**Report to
Development Permit Panel**

To: Development Permit Panel **Date:** October 20, 2003
From: Joe Erceg **File:** DP 03-233901
Manager, Development Applications
Re: **Application by Sanford Design Group for a Development Permit at
8951 and 8971 Bridgeport Road**

#2

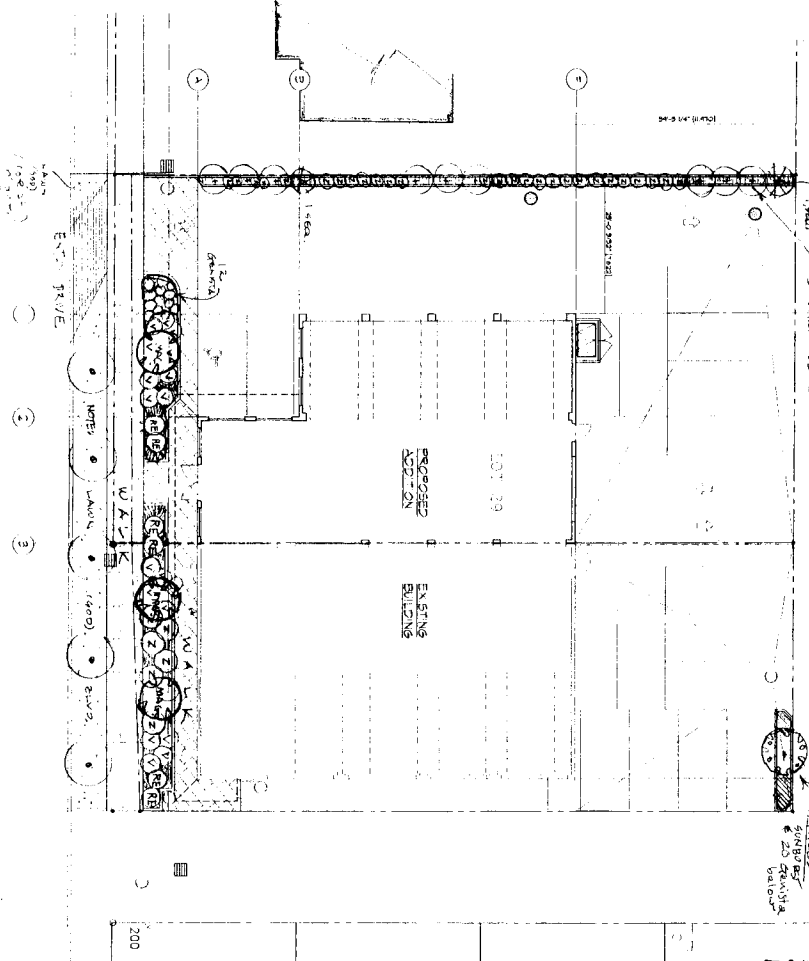
1. Conditions of Adjacency: Provide additional landscape improvements along the west property line in addition to a new 1.5 m high wood fence to provide increased screening and buffering. ***The applicant has complied; see the revised landscape architectural drawings.***

3. Landscape Design: The landscape design does not provide adequate perimeter or interior tree planting and to screen the refuse and recycling area. ***The applicant has agreed to provide a new 1.5 m high wood fence plus additional plant material along the west property line and has incorporated an enclosure wall with gates around the refuse and recycling area.***

- The north-east corner was considered crowded and a smaller variety of tree suggested. The visibility in the lane was of concern. The periwinkle was considered to be too low and a laurel hedge was suggested for more visibility. Too many Autumn Higan Cherry trees were located in the front and a wider spacing was suggested and/or a different species. ***See revised landscape drawings.***
